**BID NO. 24-013
WIC CENTER RESTROOM RENOVATIONS**

ADDENDUM NO. 2

June 18, 2024

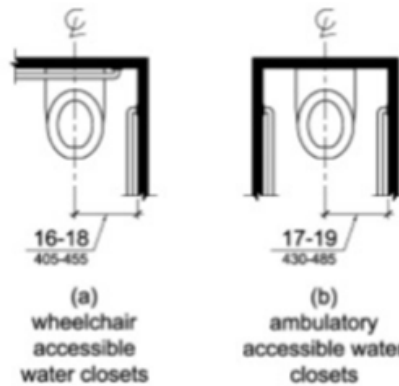
- 3. According to 2023 FBC, Accessibility 604.2 *The water closet shall be positioned with a wall or partition to the rear and to one side. The centerline of the water closet shall be 16 inches (405 mm) minimum to 18 inches (455 mm) maximum from the side wall or partition.***

During the visit, we noticed that the measurements in the toilet of the women's restroom and in the men's restroom exceeded the standards established in the FBC.

If the toilet is relocated, part of the slab will have to be demolished, and therefore the entire bathroom floor will need to be redone.

Our question: Will you adjust the scope of work in order to comply with the code?

No changes have been made to the Men's and Women's Restrooms. See attached for updates to the ADA Unisex Restroom. Contractor is to make any necessary adjustments to accessories mounting heights to bring the Unisex Restroom into compliance with ADA and FBC.

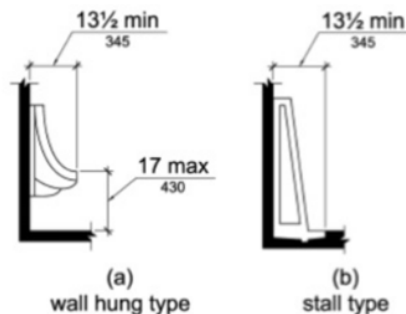
- As stated on 2023 FBC, Accessibility 605.2 *Urinals shall be the stall-type or the wall-hung type with the rim 17 inches (430 mm) maximum above the finish floor or ground. Urinals shall be 13 1/2 inches (345 mm) deep minimum measured from the outer face of the urinal rim to the back of the fixture.*

During today's visit, we observed that the urinal is 18 and a half inches from the floor, which does not comply with the FBC code. To meet the code, the urinal needs to be lowered by at least an inch and a half, which will require plumbing work. Will you adjust the scope of work to include this plumbing work to adjust the height of the urinal?

No changes have been made to the Men's and Women's Restrooms. See attached for updates to the ADA Unisex Restroom. Contractor is to make any necessary adjustments to accessories mounting heights to bring the Unisex Restroom into compliance with ADA and FBC.

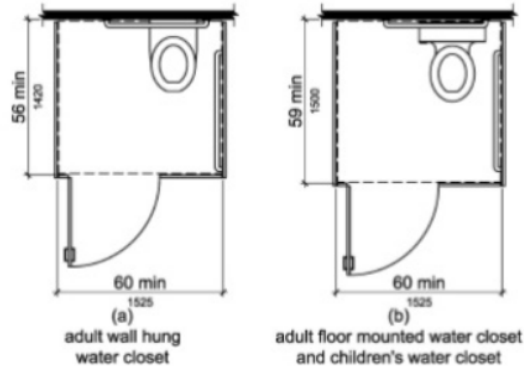
- Also according to 2023 FBC, Accessibility 604.8.1.1 *Wheelchair accessible compartments shall be 60 inches (1525 mm) wide minimum measured perpendicular to the side wall, and 56 inches (1420 mm) deep minimum for wall hung water closets and 59 inches (1500 mm) deep minimum for floor mounted water closets measured perpendicular to the rear wall.*

During today's visit, we noticed that the ADA closet does not meet the minimum measurements required by the FBC. Will you consult with the building department to allow the installation of new partitions without complying with this part of the code?

No changes have been made to the Men's and Women's Restrooms. See attached for updates to the ADA Unisex Restroom. Contractor is to make any necessary adjustments to accessories mounting heights to bring the Unisex Restroom into compliance with ADA and FBC.

MEN'S RESTROOM

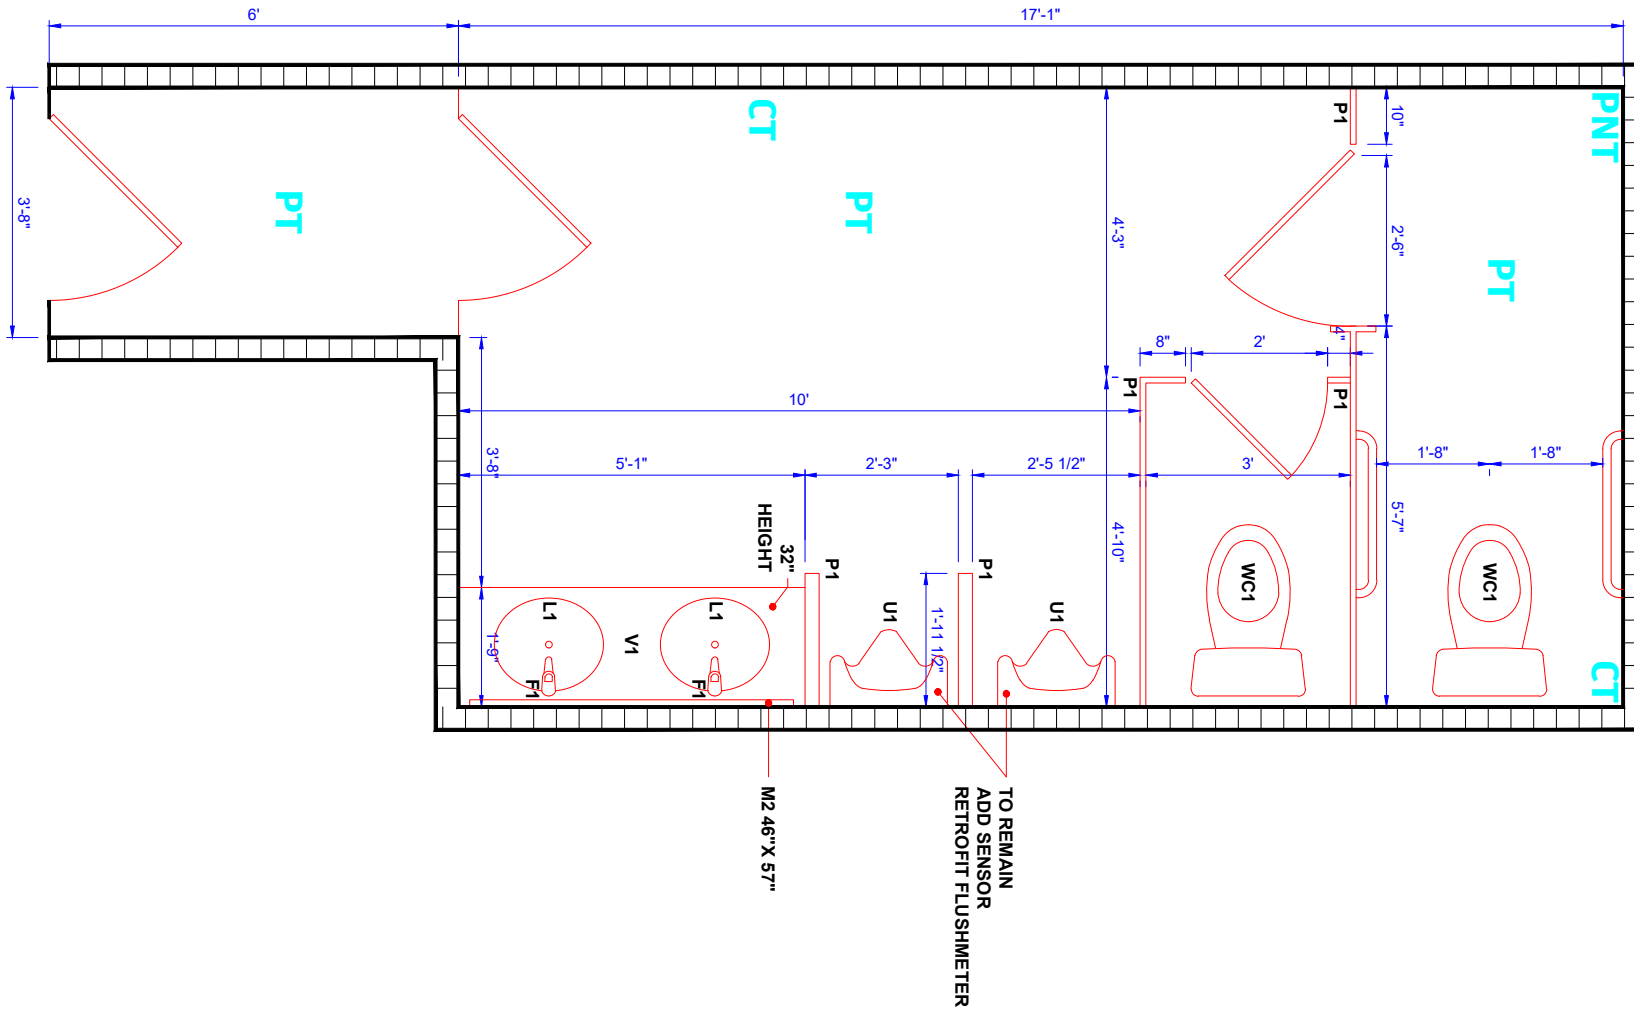
11. Bathroom Mirror sizes of 46" X 57 and 30" X 42" are not the standard sizes by the manufacture with welded frame. Would you consider similar layout to the women's restroom with (2) standard sizes above the faucets?

Reference Section II Special Terms and Conditions Item No. 2-13 and Section III Scope of Work Item No. 3-4.

<p>PROJECT NAME: WIC Center Bathroom Renovations</p>	<p>REFER TO PROJECT SPECS FOR FURTHER INFO</p>
<p>PROJECT LOCATION: 5985 10th Ave, Greenacres, FL 33463</p>	<p>FIELD VERIFY DIMENSIONS</p>
<p>WOMEN'S & ADA UNISEX RESTROOM</p>	<p>SCALE: NTS</p>

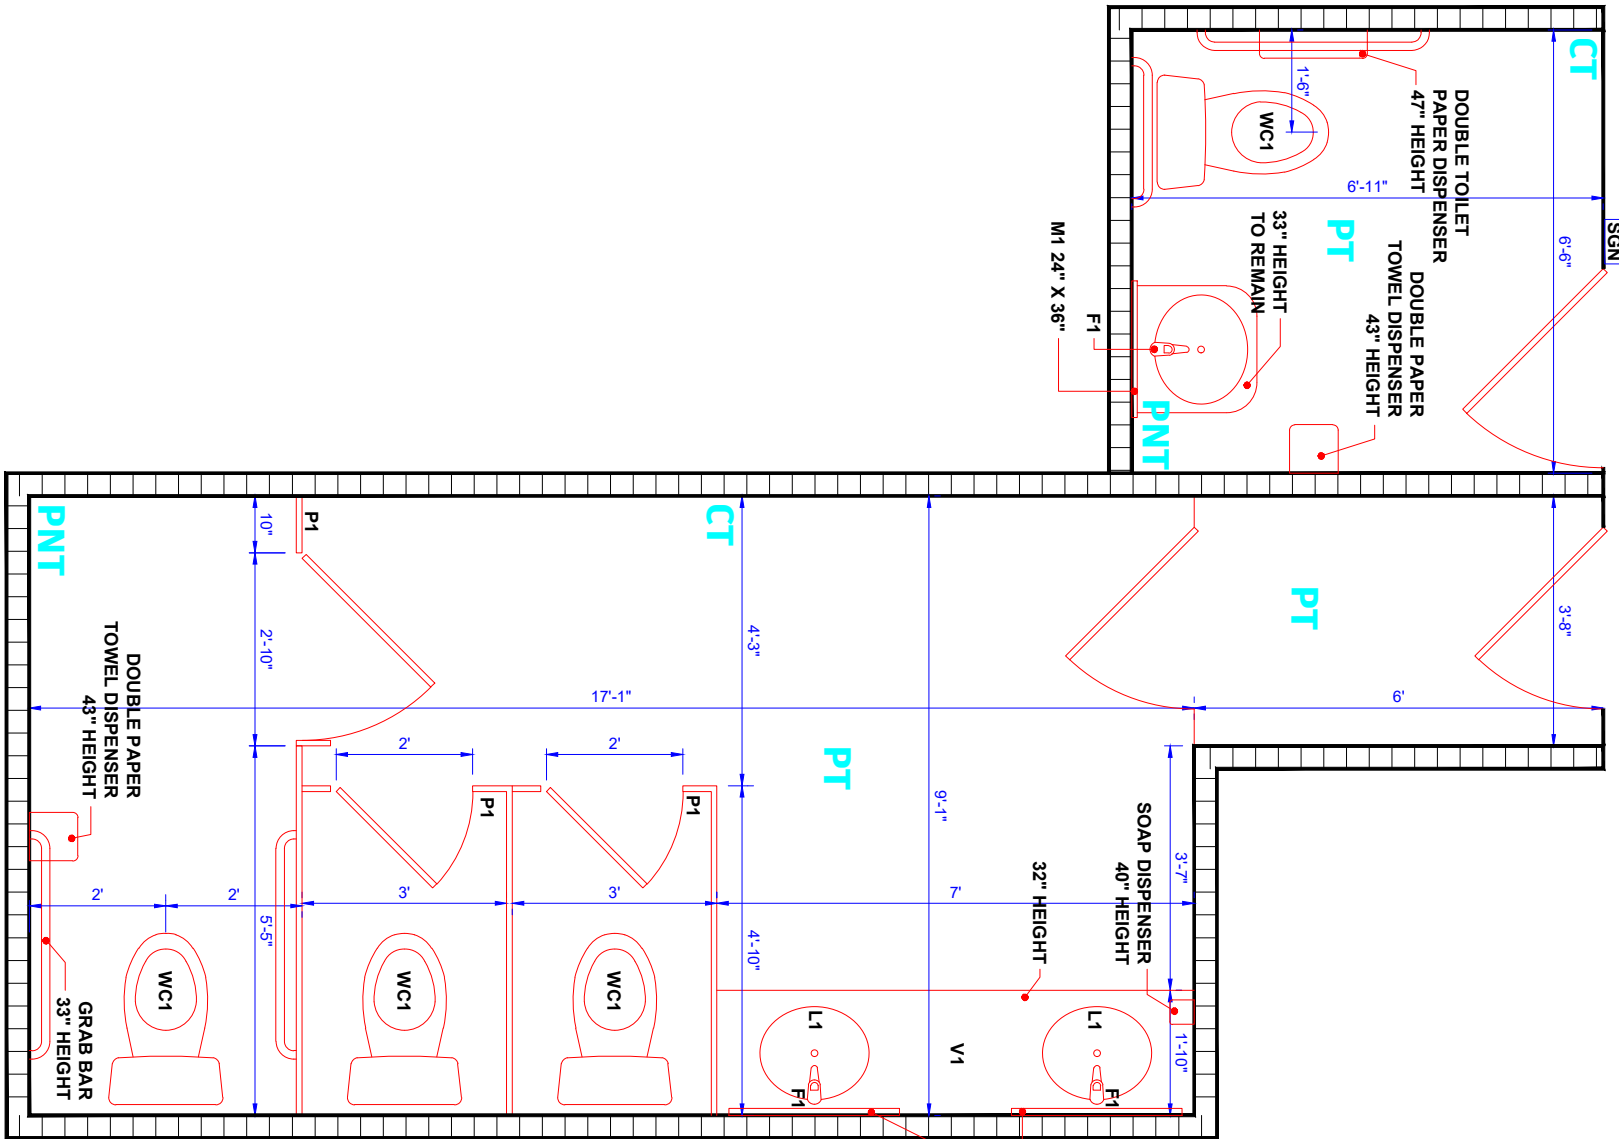
- 2. The scope of work has been updated to include painting and flooring replacement.**
